CHANGE ORDER NO. 2

OWNER	City of Baxter	DATE	August 13, 2026
CONTRACTOR	RL Larson Excavating, Inc.	SEH No.	BAXTE 184519
ENGINEER	SEH	City No.	4068
Project	2026 Clearwater Road, North Lynndale Area, and Brentwood Circle Street & Utility Improvements

Save: 7/14/2026 11:34 AM avoit Plot: 7/14/2026 11:36 AM X:\AE\B\BAXTE\184519\5-final-dsgn\51-drawings\10-Civil\dwg\sheet\Bx184519PP_ST_CLEAR.dwg

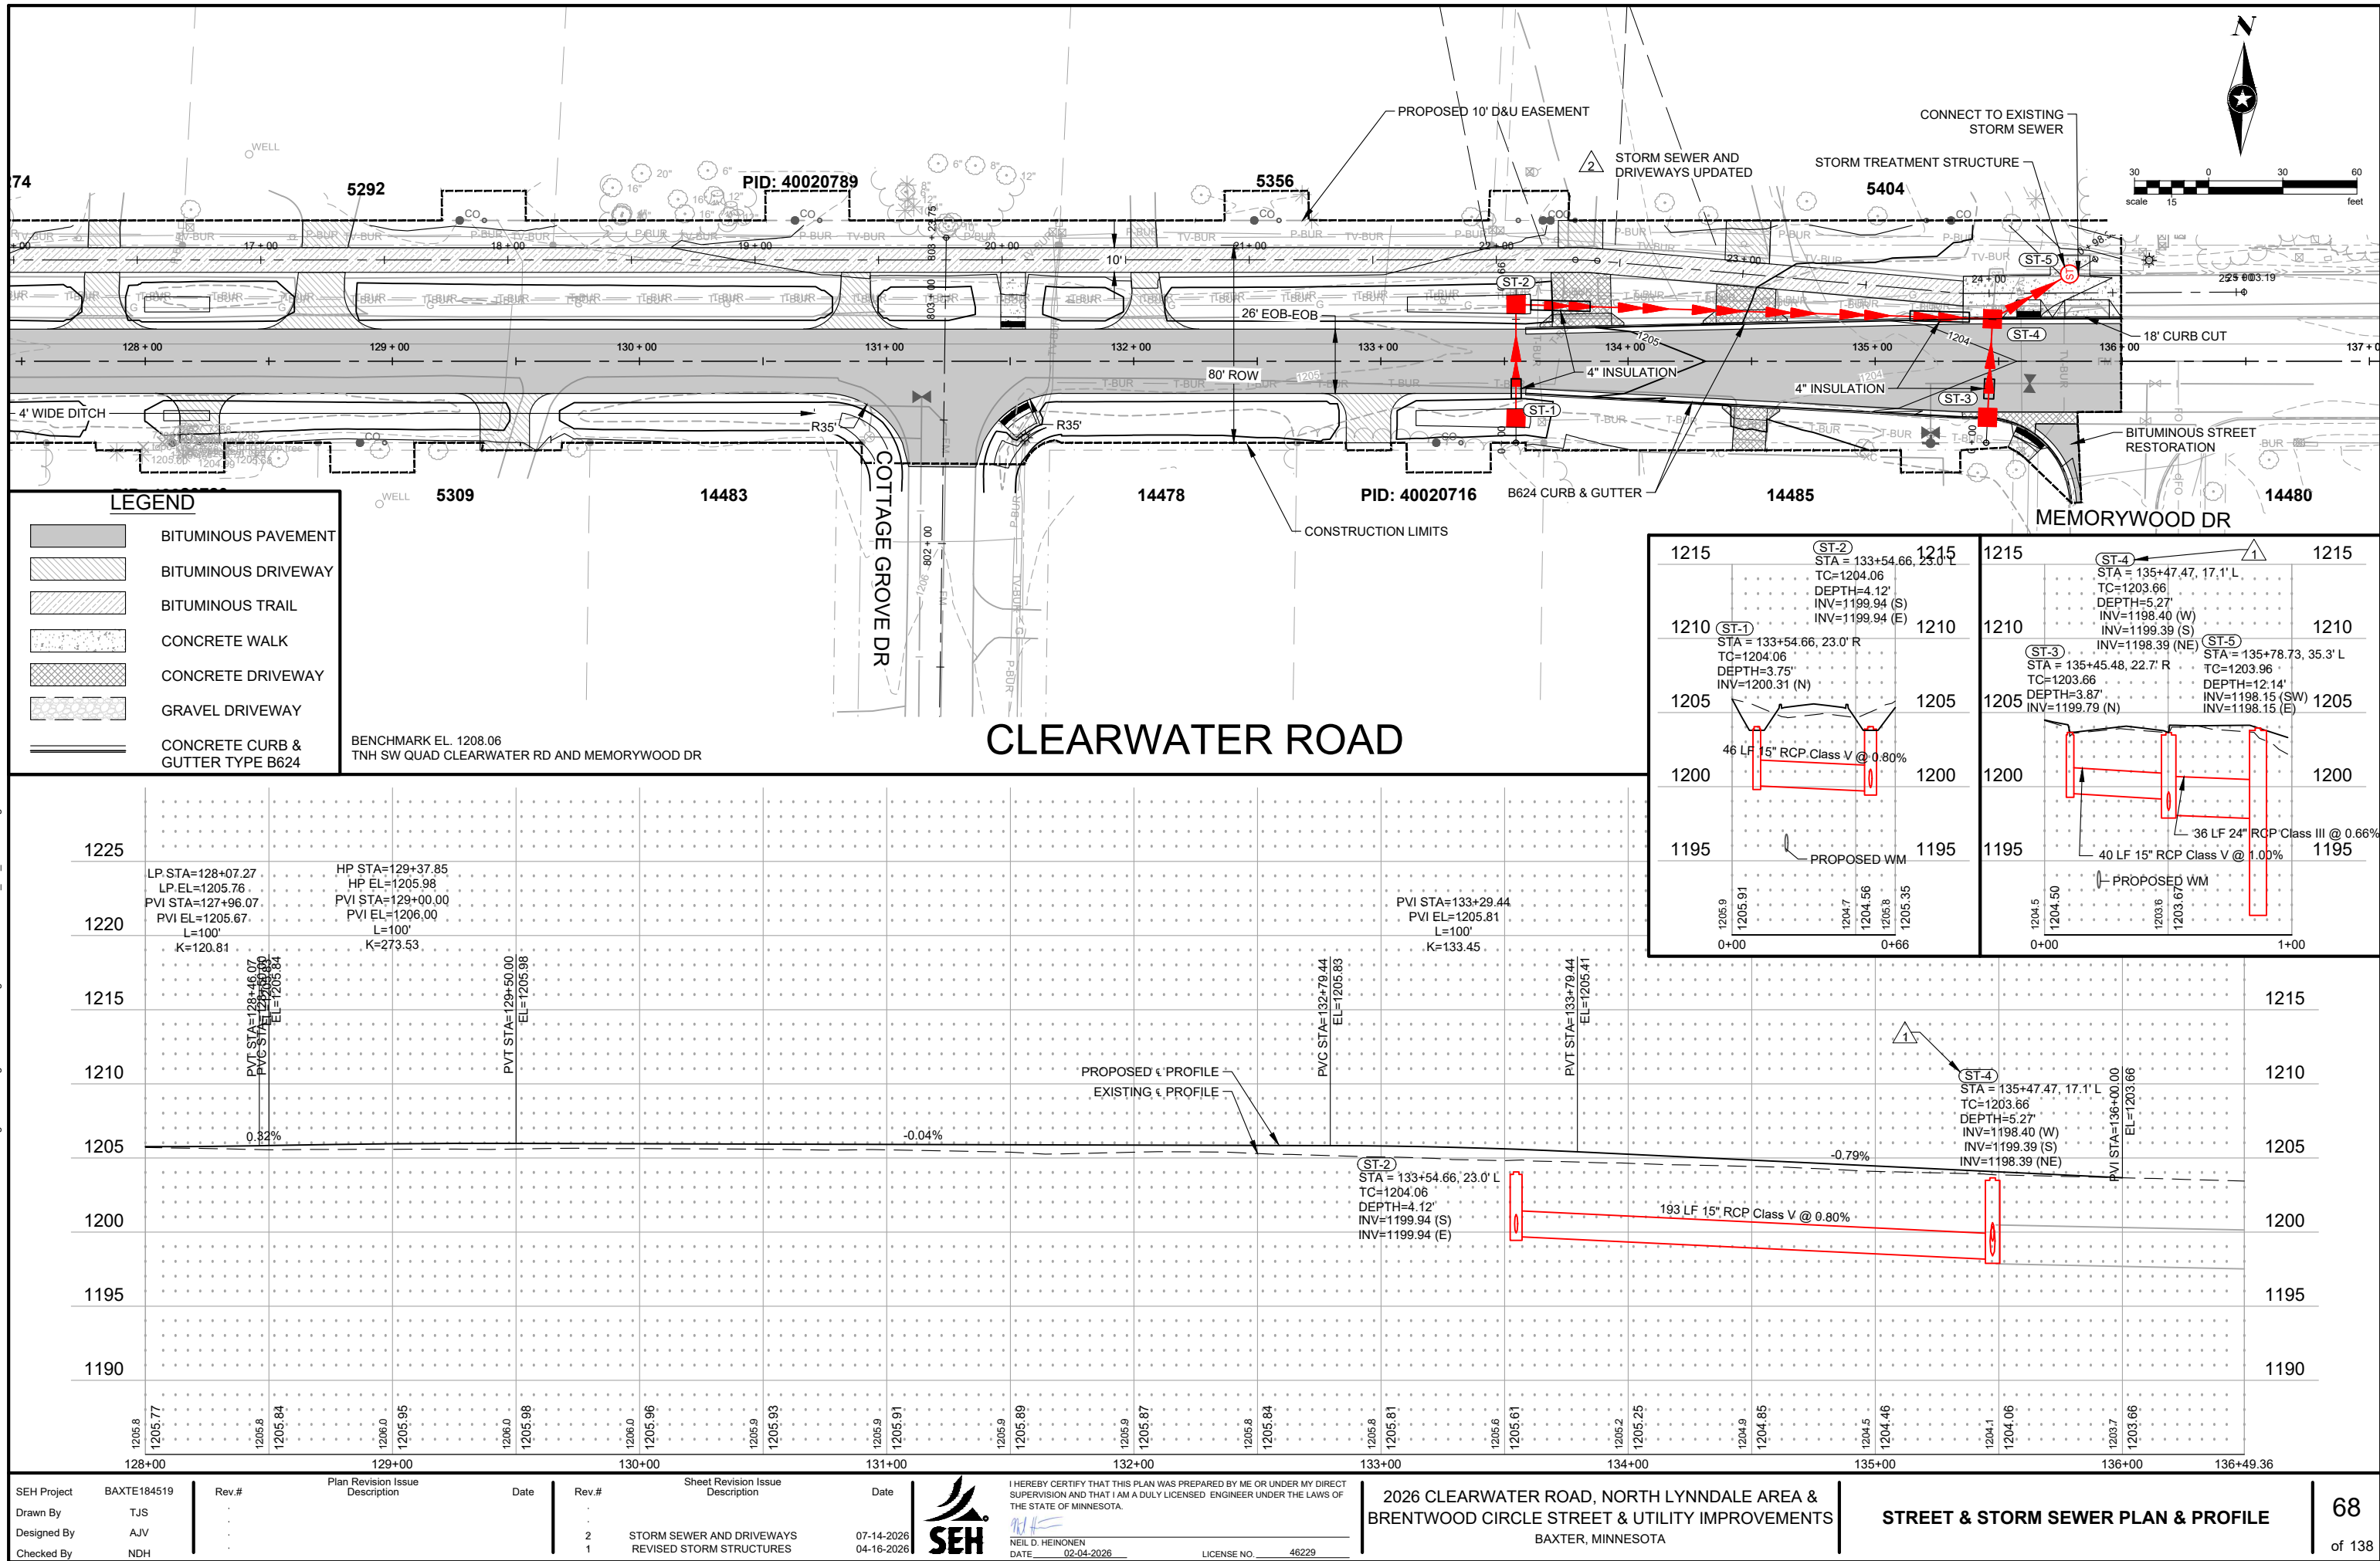
After discussion and review with City Staff, a short segment of existing 10-inch watermain and the existing 12-inch watermain along the south side of Clearwater Road between Welton Road and Northwood Drive will be left in place. This change results in a reduction of several contract quantities and requires the installation of a 12-inch by 12-inch wet tap to connect the proposed watermain. Additionally, because the originally specified 12-inch valves had already been procured, this revision will result in associated valve restocking fees, which are included in the cost impacts of this change.

As part of a plan change in this area, existing forcemain stubs along Northwoods Drive and Cottage Grove Drive will be abandoned in place. This change allows the removal and restoration limits to be reduced, resulting in several quantity reductions.
